## **Accelerated gate two queries process**

Strategic solution(s)	Water Recycling
Query number	SWR004
Date sent to company	14/12/2021
Response due by	16/12/2021

Option B.2

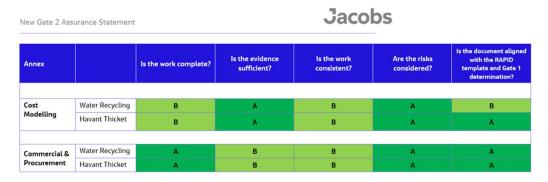
• You refer on p. 287 to the estimation of uncertainty for the project. We assume from the table on p.280 that the uncertainty allowance is £6.8m. Is this correct?

- The estimating uncertainty allowance for B.2. (no CeraMac) is £6.8m
- The calculation of estimating uncertainty for option B.2 can be reached by deducting the "infra" cost (£68,926,811.98) and the "non infra" cost (£100,265,274.33) from the Net Direct Cost total (£175,959,769.76) which provides an estimating uncertainty allowance of £6,767.683.45.
